**REGULAR MEETING
OF THE VINEYARD PLANNING COMMISSION,
Wednesday, June 16, 2021 at 6:00 p.m.**

4.2 Discussion and Action – 4Life Building Expansion Site Plan and Preliminary Plat

Date: June 16, 2021
From: Briam Amaya Perez, Planner II
To: Planning Commission
Item: 4Life Preliminary Plat and Site Plan
Address: 400 E 1600 N, Vineyard, Utah, 84059
Applicant: 4Life Properties LLC
Owner: Nate Buhler

LP100 PLANTING PLAN
SCALE: 1" = 20'

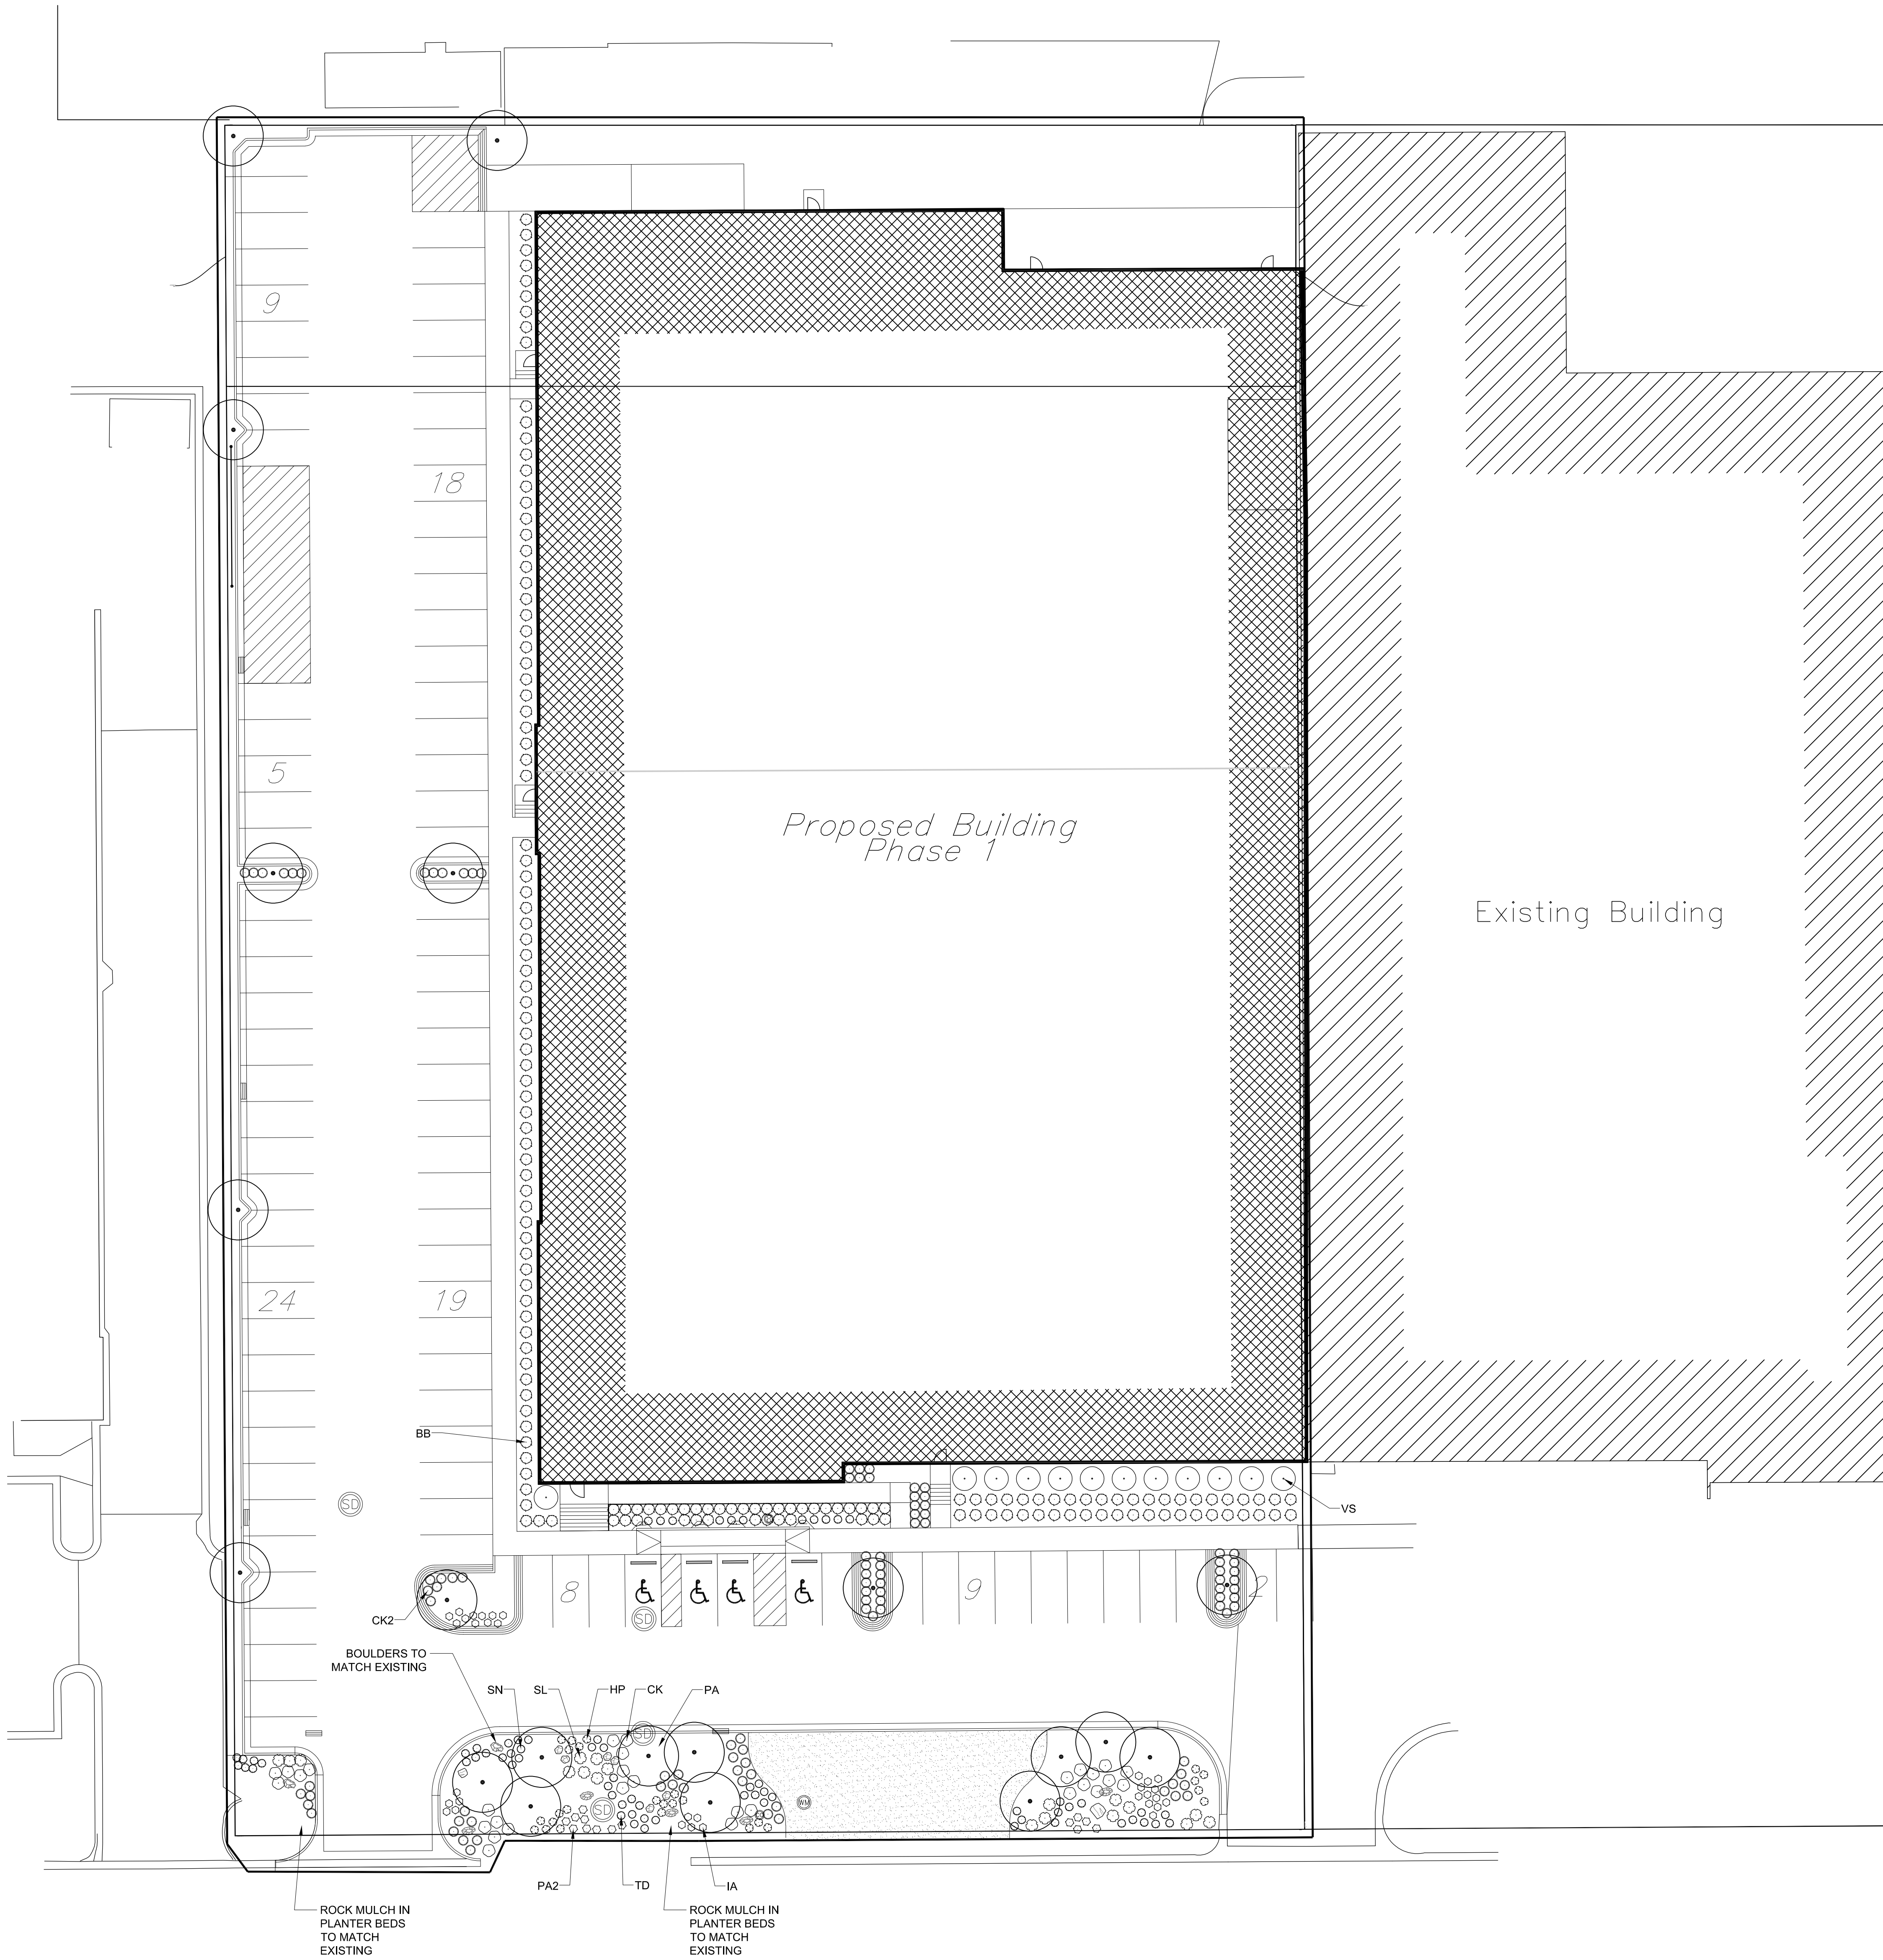
15.36.030.13 Landscaping Design Standards	Landscape improvements shall be an integral element of all subdivision and site plan designs. Landscaping shall complement the architecture of all proposed buildings and structures and provide visual interest and variety, provide screening elements, provide year-round site beautification, blend with the natural landscape and highlight building design features.	The proposed site plan meets this requirement.	☒ Yes ☐ No ☐ N/A

15.36.030.13.c Landscape Materials	All proposed plantings and site materials should be consistent with (but not uniform) and of a similar scale with existing natural neighboring landscape, and adjacent streetscape areas where appropriate. Drought tolerant “xeriscape” landscaping is encouraged. Landscaping improvements may also include berming, contouring, rocks, and boulders.	The proposed site plan meets this requirement.	☒ Yes ☐ No ☐ N/A

15.36.030.13.d Plant Size, Spacing, and Scale	The size and spacing of landscape elements shall be consistent and establish a coordinate relationship to any existing or proposed streetscape plantings. The size and space of landscape elements shall also be of appropriate scale and character to all proposed buildings, structures, and features.	The proposed site plan meets this requirement.	☒ Yes ☐ No ☐ N/A

15.40.080.1.b. Minimum Size of Plantings	Unless otherwise specified herein, all required deciduous trees shall be a minimum of 2-inch caliper in size. All evergreen trees shall be a minimum of 6 feet in height. All shrubs shall be a minimum of 5 gallon in size.	The proposed trees have been approved by the Public Works Department.	☒ Yes ☐ No ☐ N/A

15.40.080.1.d. Plant Materials	Plants shall be drought tolerant and well-suited to the soil conditions at the project site. Plants with similar water needs shall be grouped together in landscape zones as much as possible. The applicant shall provide water requirements for all plant material. Plant materials shall be chosen from the approved Vineyard Tree Manual.	Not applicable.	☐ Yes ☒ No ☐ N/A

15.40.080.1.e. Limitation on the Use of Turf.	Turf shall be limited to 60% of the total landscaped area. All landscape areas, other than those designated for recreation purposes such as parks and playfields as determine by the City Planner are subject to this limitation.	The proposed building meets this requirement.	☒ Yes ☐ No ☐ N/A
